CODAN

Unreliable communication of the 8570 Remote Control Console

Head Office	© 17-00183 Issue 2, August 1999	Page 1 of 4	
Codan Pty Ltd ACN 007 590 605 81 Graves Street Newton South Australia 5074 Telephone +61 8 8305 0311 Facsimile +61 8 8305 0411	Codan (UK) Ltd Gostrey House Union Road Farnham, Surrey GU9 7PT United Kingdom Telephone +44 1252 717 272 Facsimile +44 1252 717 337	Codan Pty Ltd Suite 11A, 2 Hardy Street South Perth Western Australia 6151 Telephone +61 8 9368 5282 Facsimile +61 8 9368 5283	Codan Comunicaciones Ltda. Av. 11 de Septiembre 2155, Of. 701/A Edificio Panorámico Providencia Santiago, CHILE Teléfono +56 2 373 9577 Facsimile +56 2 373 9579

Figure 1: Location of Remote Control Filter PCB on the Audio Processor and Power Supply Unit PCB

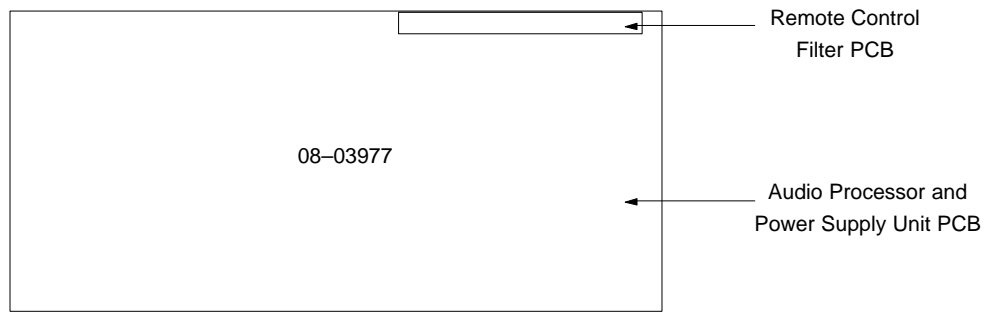
The Remote Control Filter PCB is the small PCB mounted upright in the right-hand corner of the Audio Processor and Power Supply Unit PCB (see Figure 1).

Figure 2: Location and orientation of R502 on the Remote Control Filter PCB

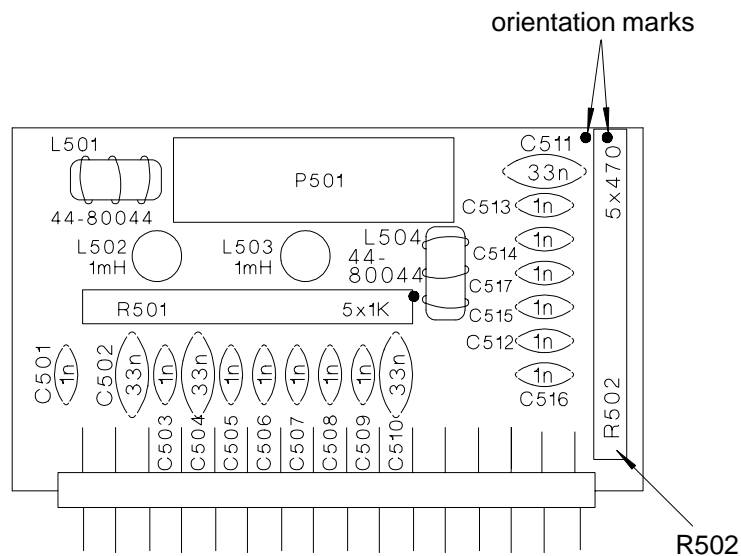
The unreliable communication of the 8570 is caused by excessive series resistance of the resistor pack R502 (part number 40–83101–500) on the Remote Control Filter PCB. This causes loading of the I²C Clock and Data lines.

- Locate R502 on the Remote Control Filter PCB (see Figure 2).

- Measure the resistance between pins 1 and 2.

If the resistance is $\approx 1 \text{ k}\Omega$, then the resistor pack R502 needs replacing.

- Desolder and remove R502.
- Observing the correct orientation, fit the replacement resistor pack (part number 40-82471-500) in the position that R502 occupied.
